From:
Monks Orchard Residents' Association
Planning

Reference: 19/00229/FUL
Application Received: Fri 18 Jan 2019
Application Validated: Fri 18 Jan 2019
Address: 197 Shirley Road Croydon CR0 8SB
Proposal: Erection of two storey detached (one-bedroom) dwelling.
Case Officer: Sera Elobisi
Consultation Close: Thu 21 Feb 2019
Deadline determination: Fri 15 Mar 2019

We object to this proposed development for reasons set out in the following submission.

Fig 3 – Proposed Plans and Elevations

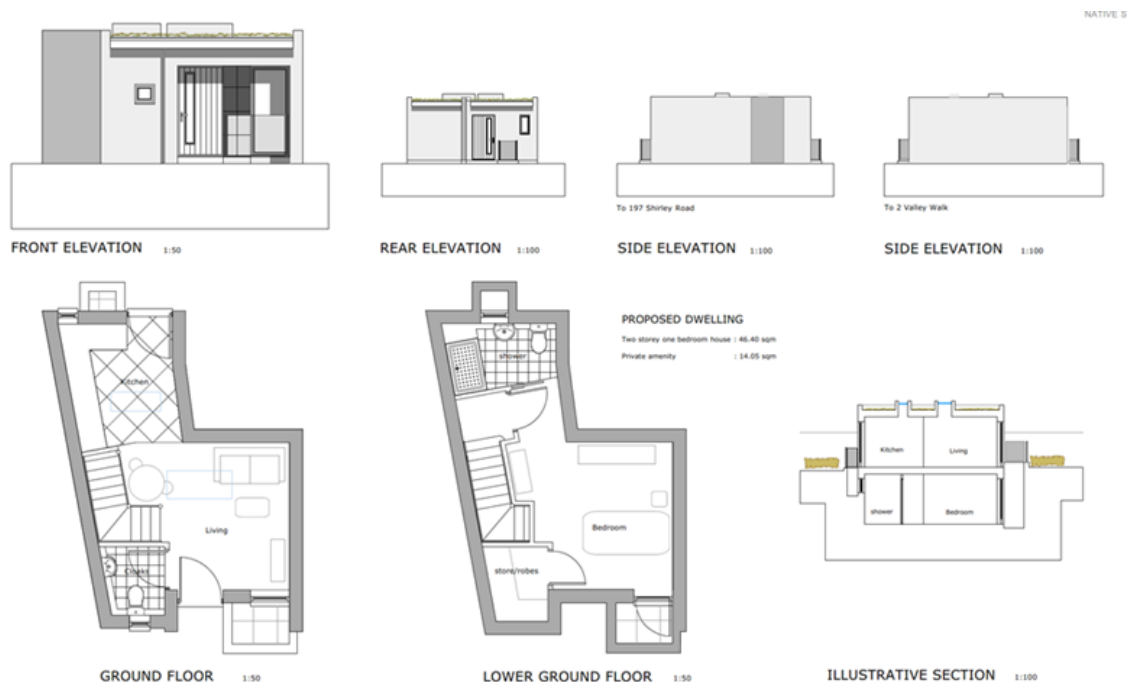
The Proposed development does **NOT** respect the **pattern and grain of the existing spaces and streets in orientation, scale, proportion and mass** and therefore is **Non-compliant to the London Plan Policy 7.4 a)**. The proposal takes no account of the **existing buildings and structures to make a positive contribution to the character of the place and is therefore is Non-compliant to the London Plan Policy 7.4 d)**.

In fact, the proposed structure would be **totally out of character with surrounding dwellings** by the **obvious architectural characteristics** and is **forward of the existing building line, fronting Valley Walk** and the fact that the dwelling would have a lower ground floor in a locality with no other properties with basements.

This design proposal is completely out of character with the surrounding dwellings. The proposal does **NOT build on the positive elements** that can contribute to establishing **an enhanced character** for the future function of the area.

We therefore **object** to the **architectural design** of the proposal as **totally inappropriate for this locality at this time** as the **predominant character defines the area of pitched roofs and conventional build structures of brick buildings with conventional tiled roofs.**

This development would be next door to the podiatry clinic (see Fig 3). Clients are normally elderly and also not steady on their feet and normally arrive by car as a regular means of travel for visitors to this clinic resulting in additional on-street parking in this vicinity.

Fig 5- Site Location Plan

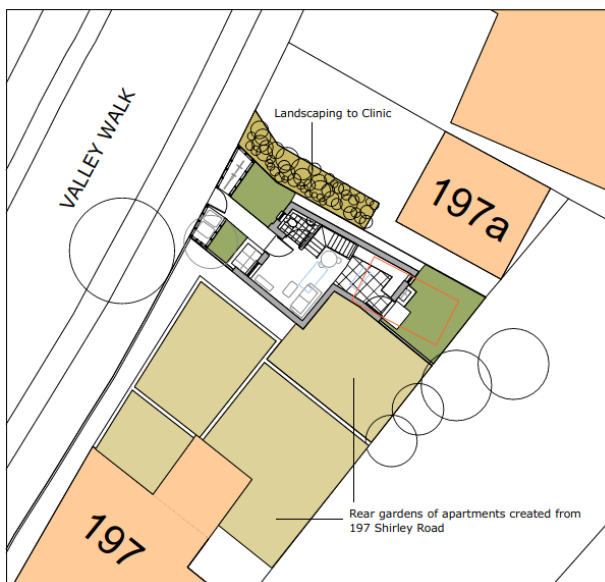
The proposal **fronts Valley Walk** and is positioned **forward of the predominant building line** of all the properties in Valley Walk which is **inappropriate and in contravention of Policy DM10 para 6.47** (See Fig 5). The Clinic at 197a follows the Valley Walk building Line.

Fig 7 – Lower Ground Floor

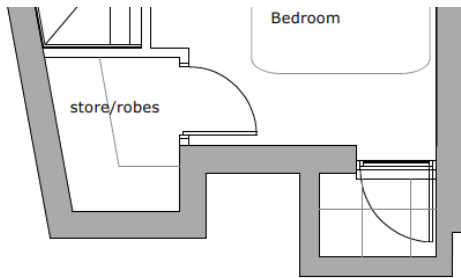
The proposed development is very close to areas at risk of **surface water flooding** which indicates **basements in this locality would be inappropriate.**

The Lightwell could become filled with surface water flooding and seep through the access door as the jambs would unlikely be completely water tight. If this occurred overnight, the water level inside the bedroom could gain significant height which could be very dangerous to a single sleeping occupant.

The amount of natural light from the lightwell would be extremely limited as it is only the size of a door and the area open to the elements is extremely limited; it is not possible to scale off the plans provided to measure the depth of the pit or the floor area as there is no graticule scale shown on the plans to scale from.
